ADDENDUM

NO. 3

PROJECT NAME: Lehman High School 2025 Additions and Renovations

ADDENDUM DATE: 14 May, 2025

PACKAGE	VOLUME
Job No. 01954-08-01	Sheet No. ISSUE FOR BID
Drawn By: RAU	C8.02
Date: 05/15/2025

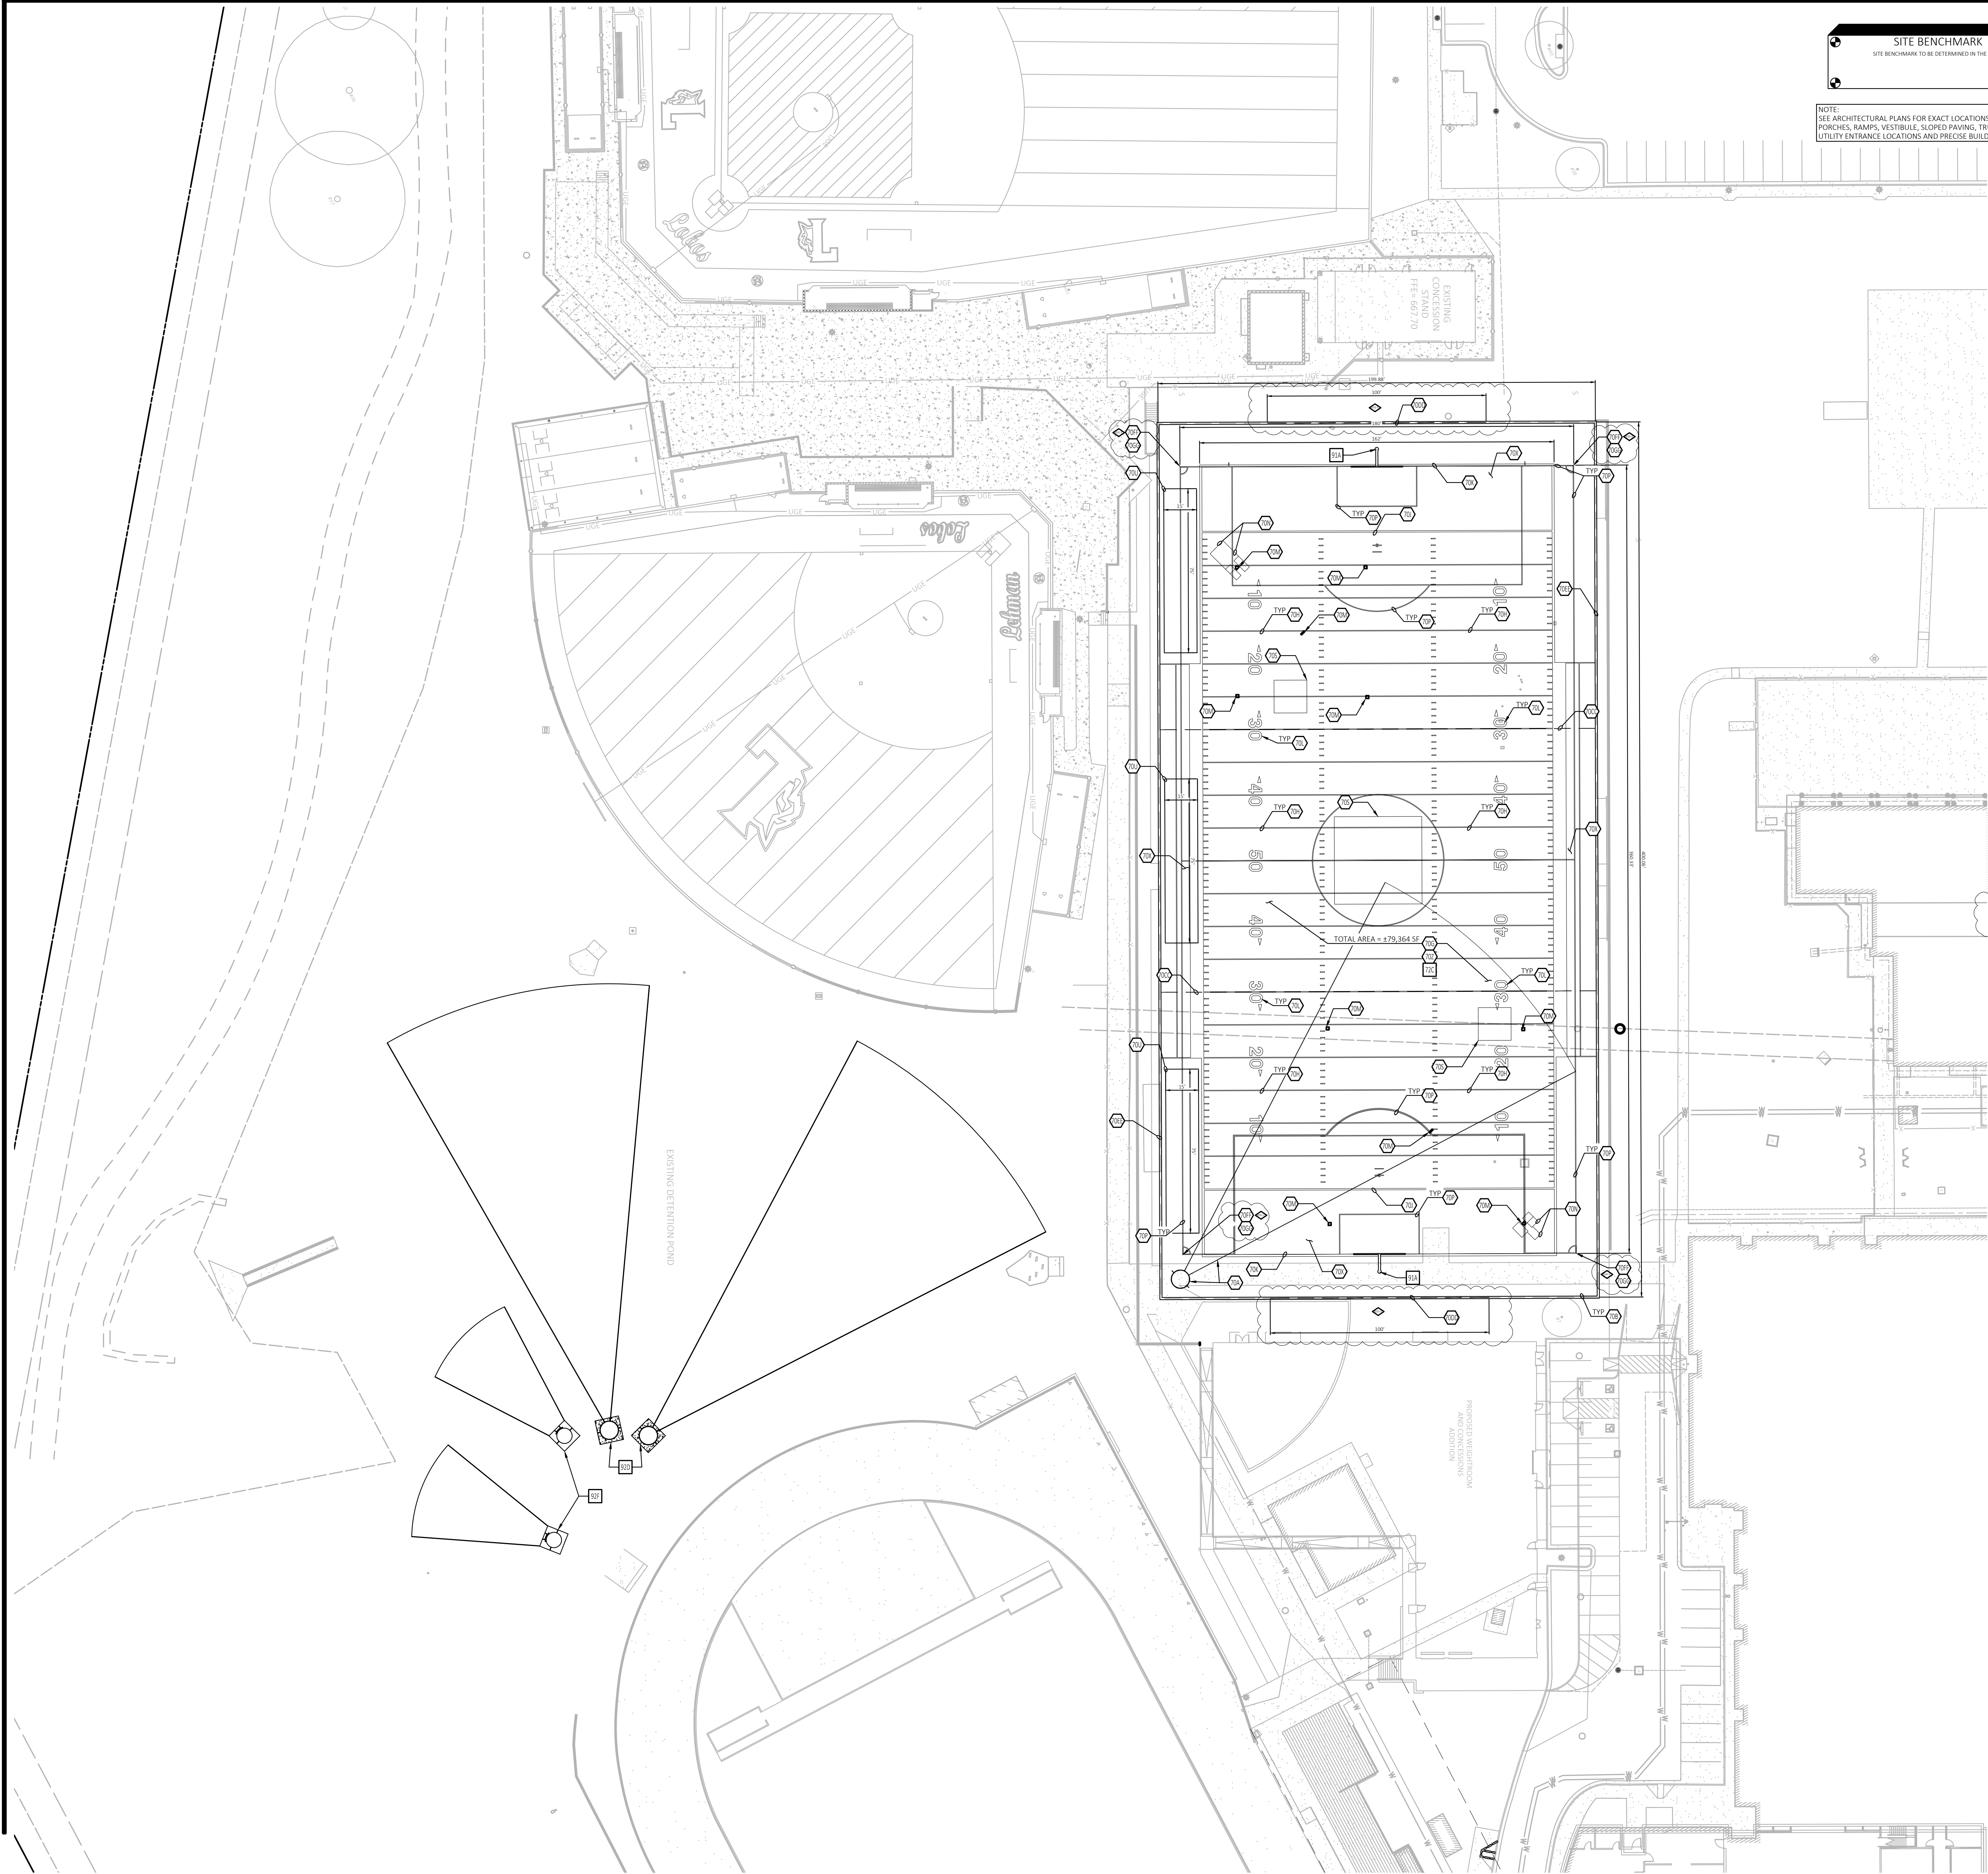
- 1) Addition of storm lines to utility vaults.
- 2) Modification of existing storm line.

1 FOUNDATION PLAN - AREA A

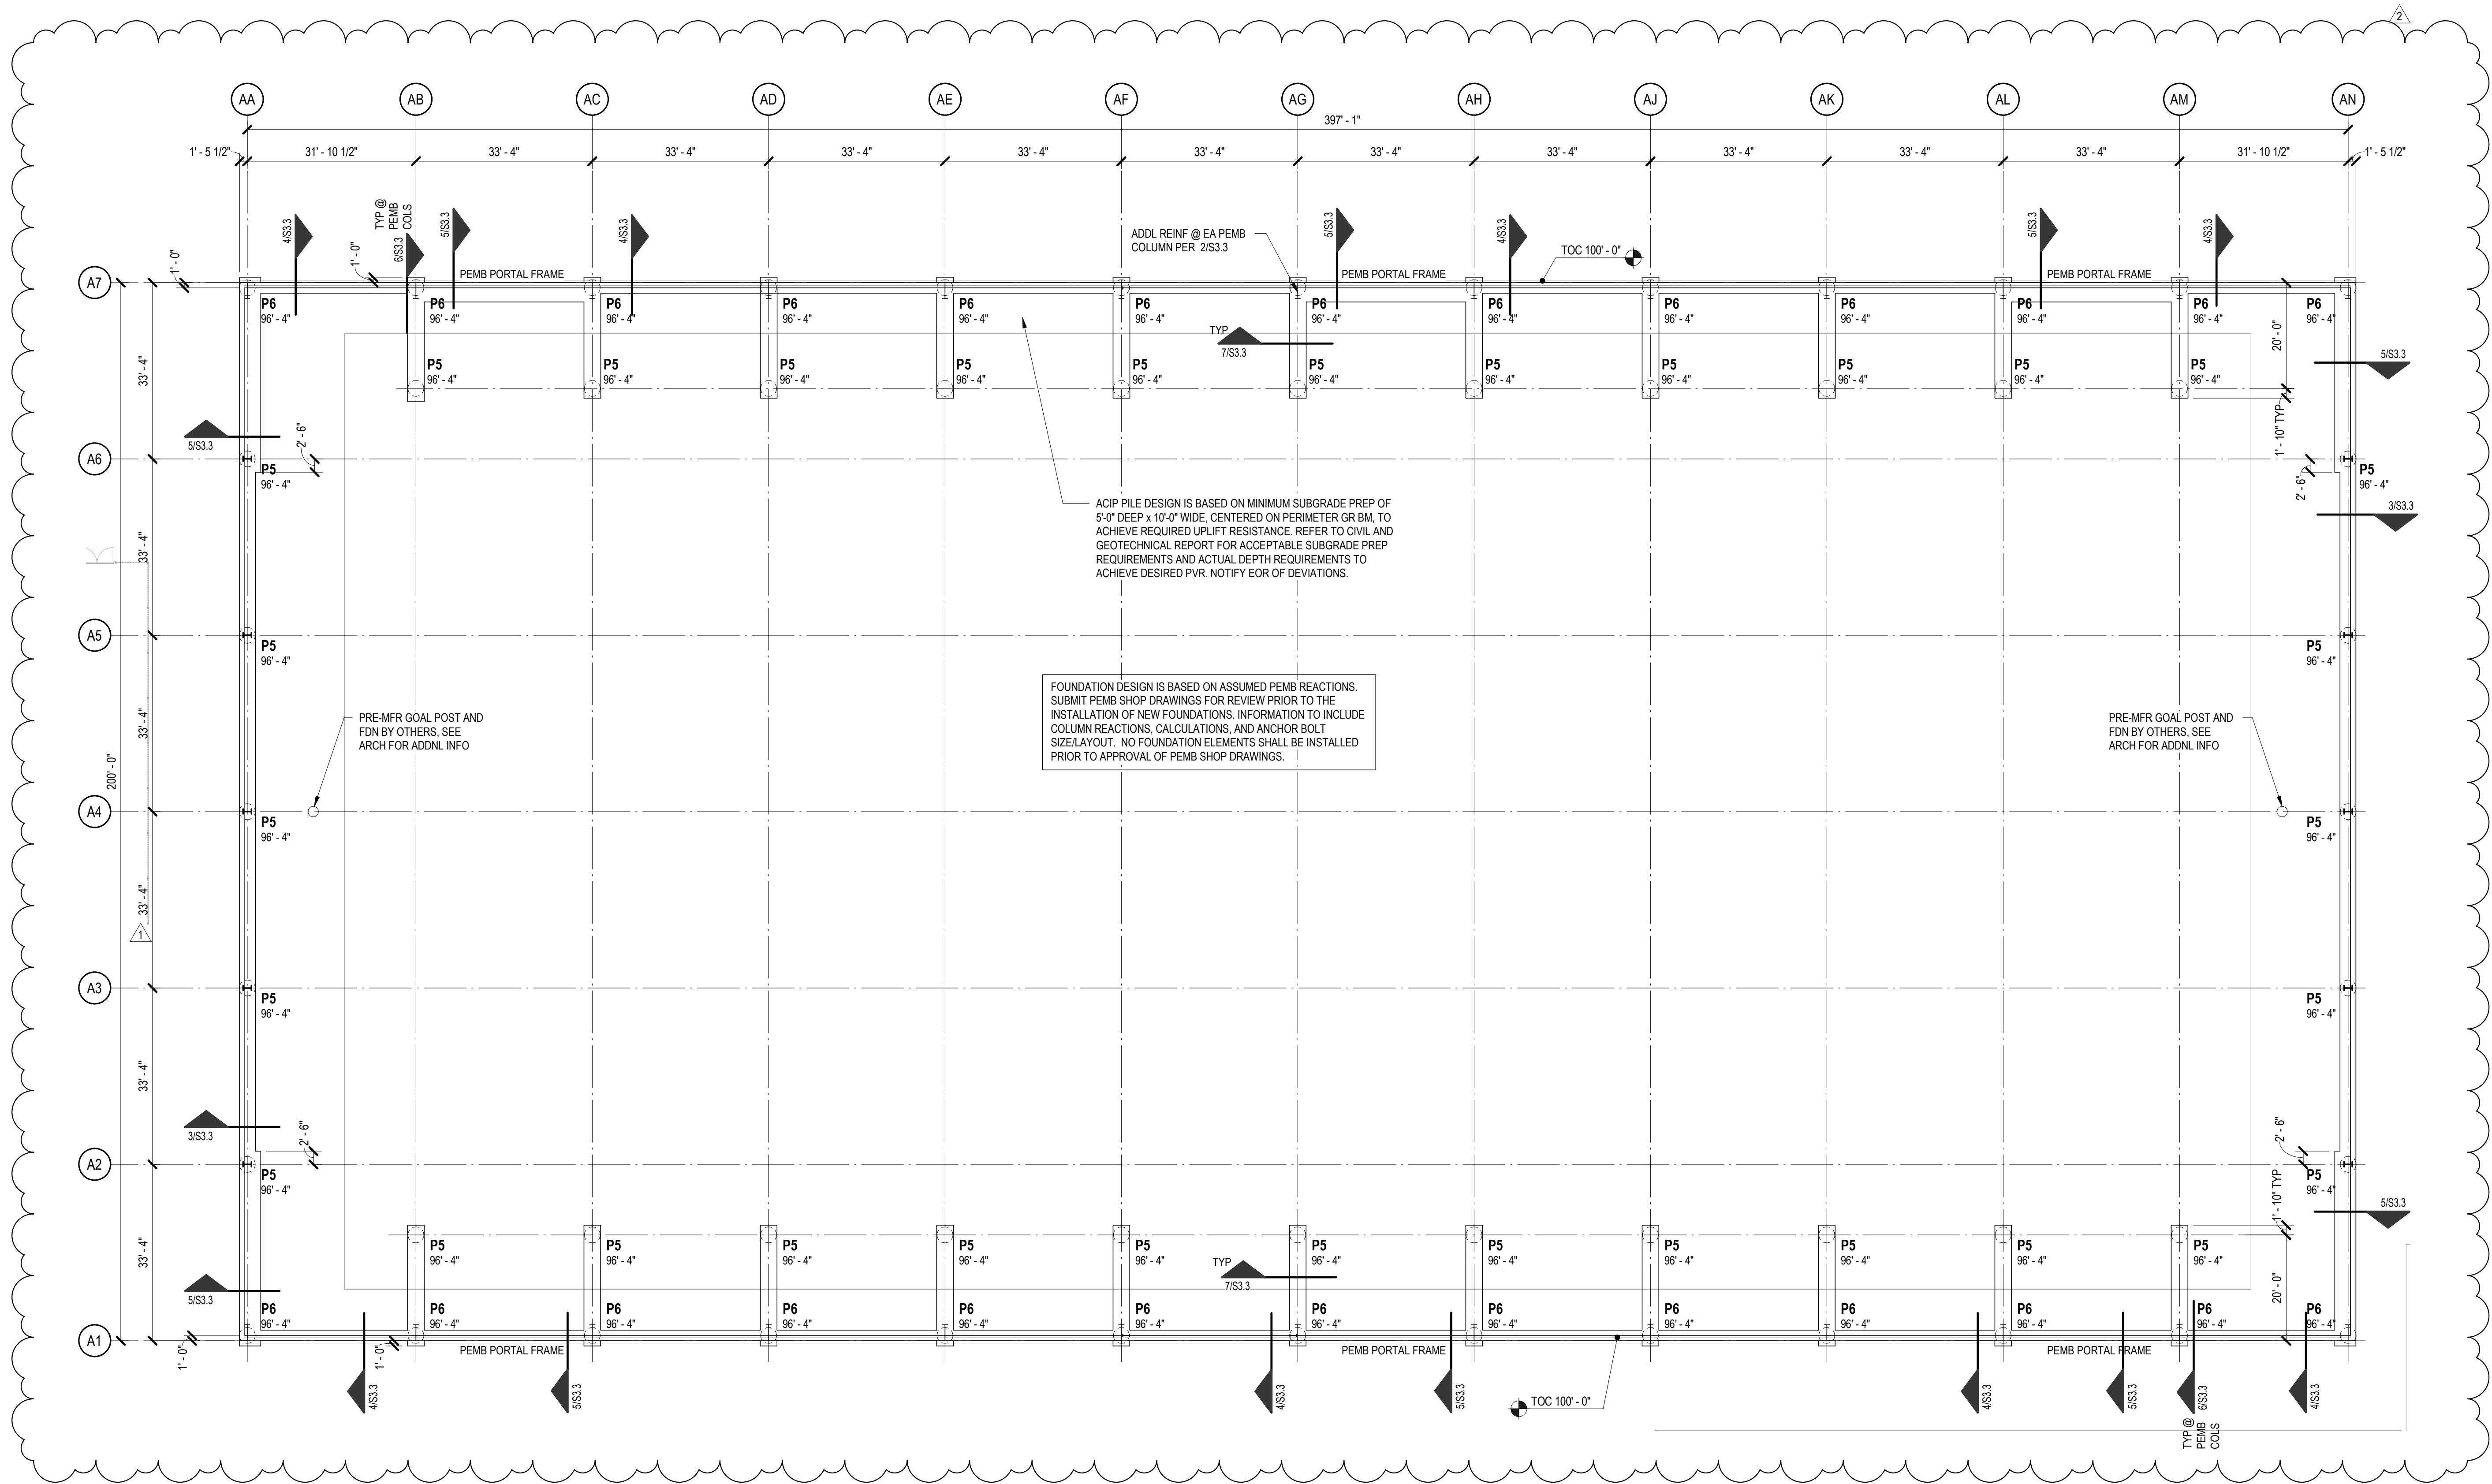
- 1) Revised dimensions

1 ROOF FRAMING PLAN - AREA A

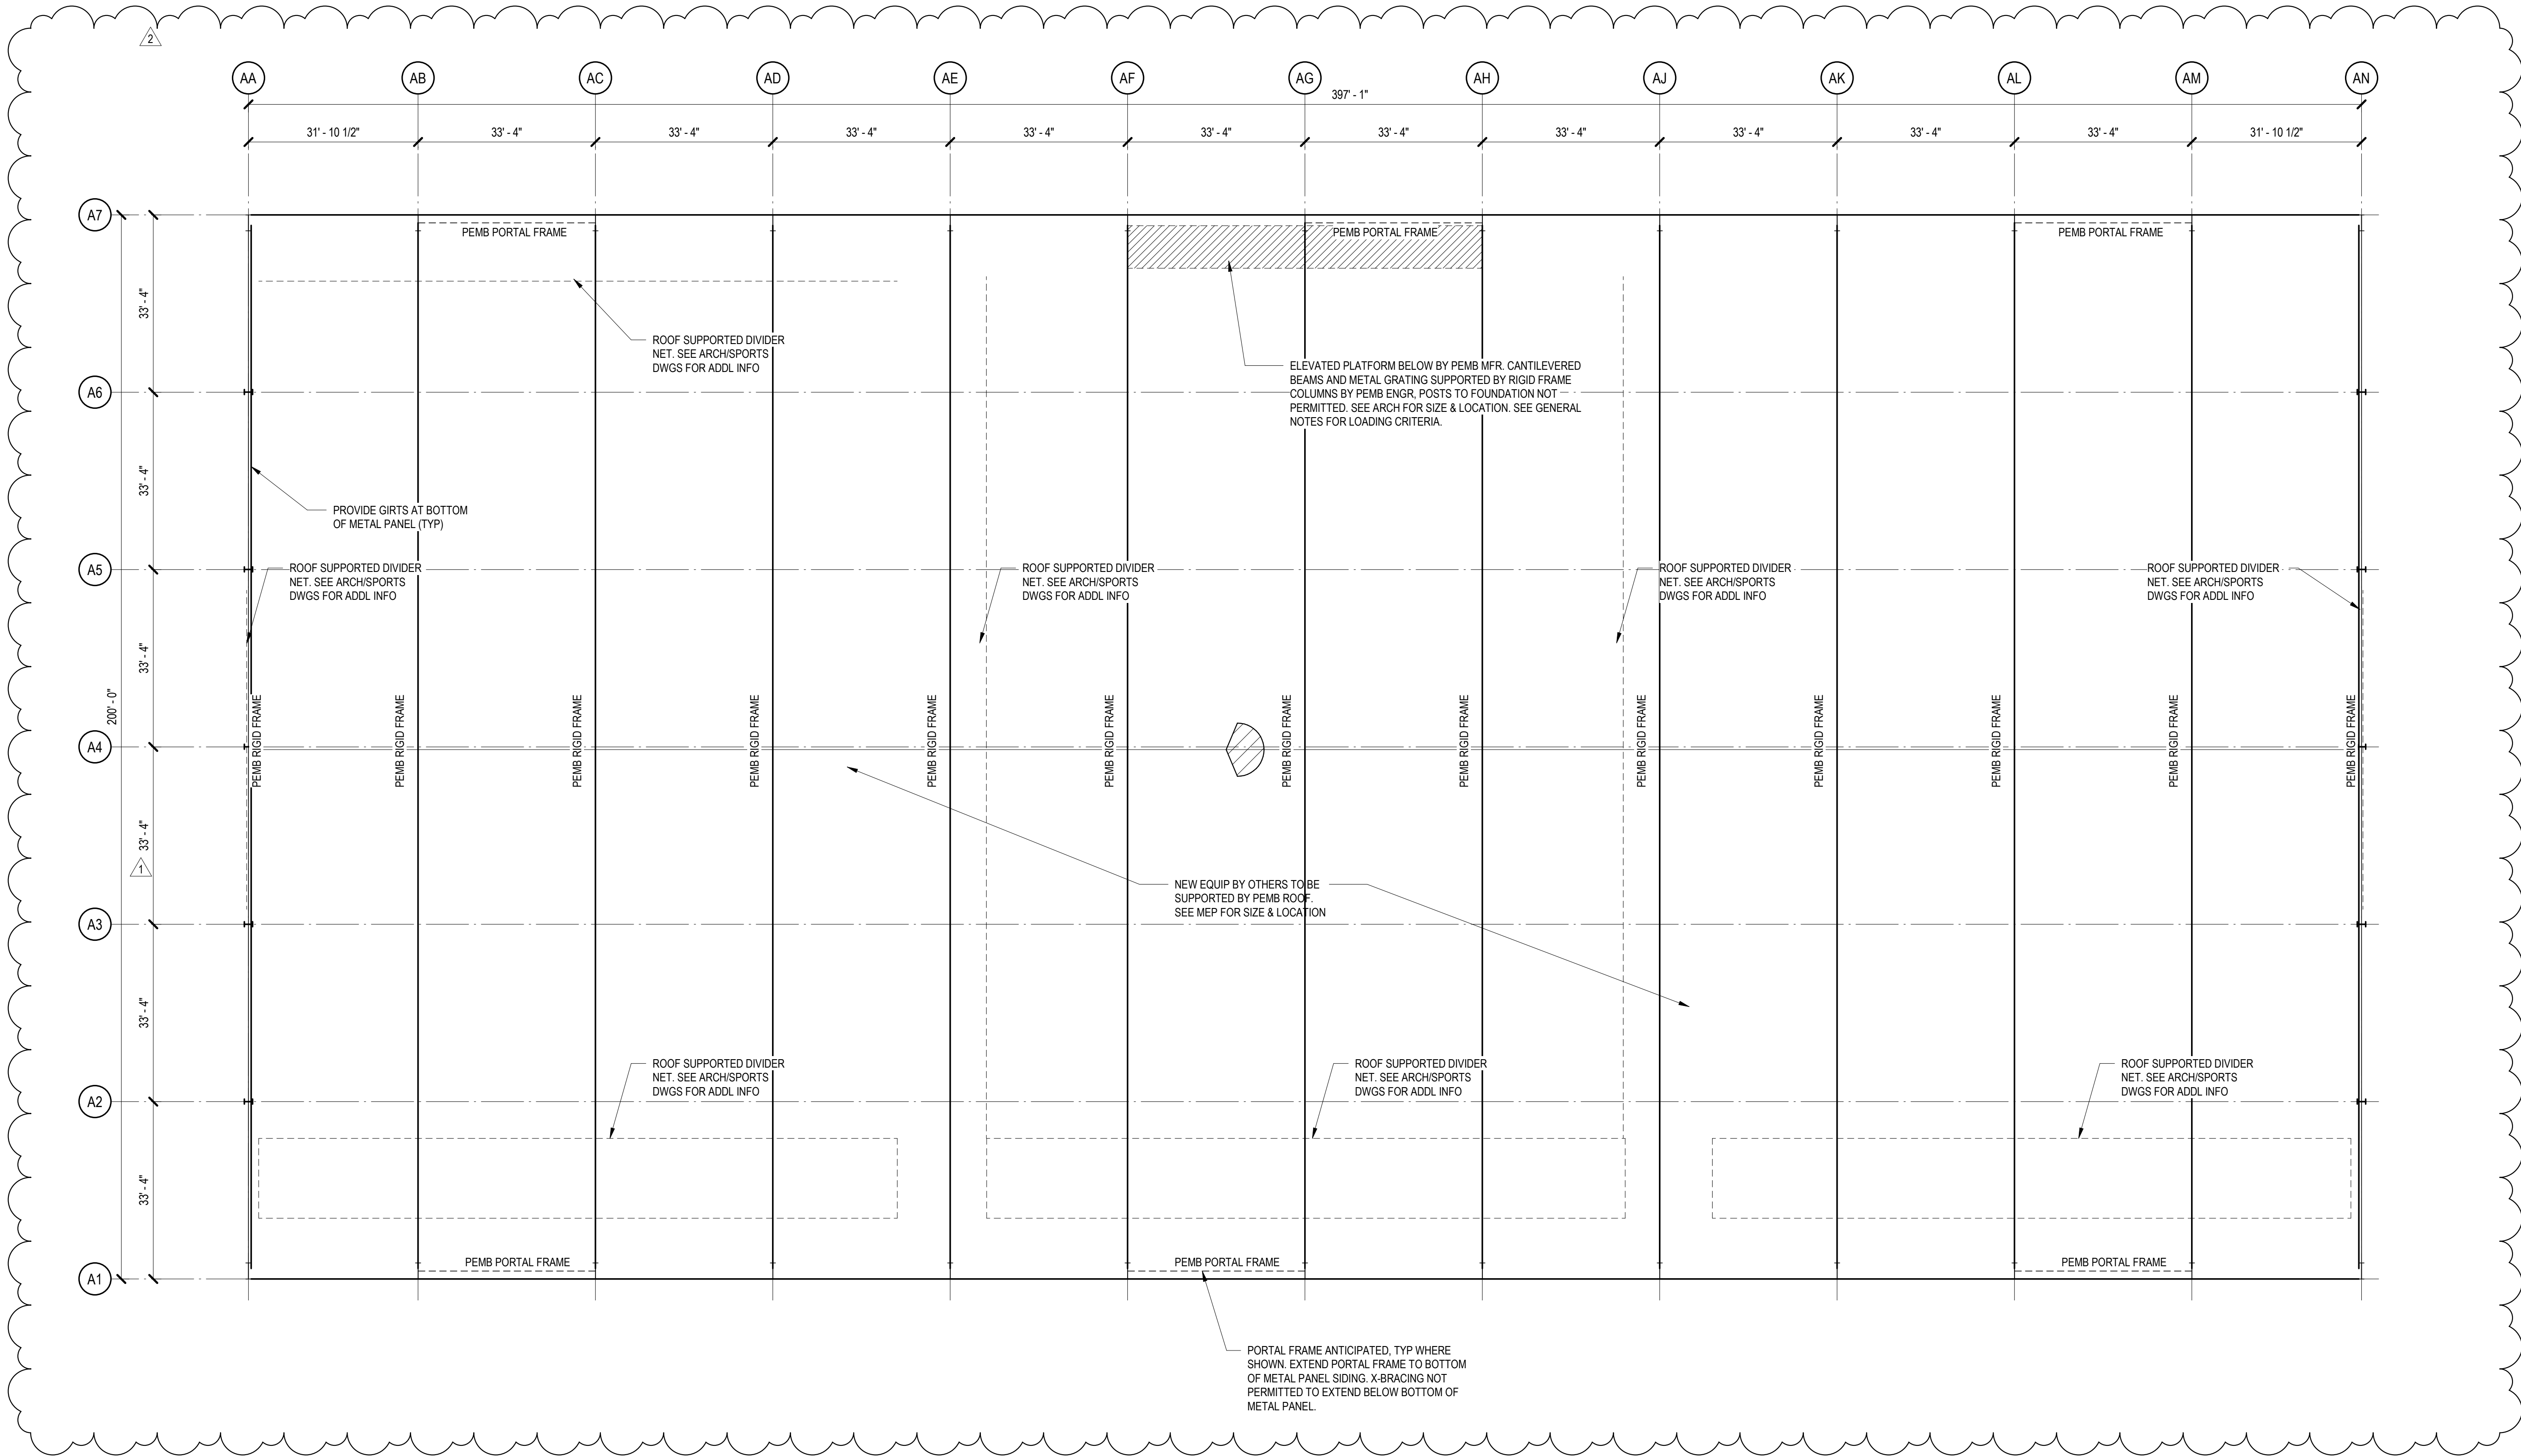
- 1) Revised dimensions
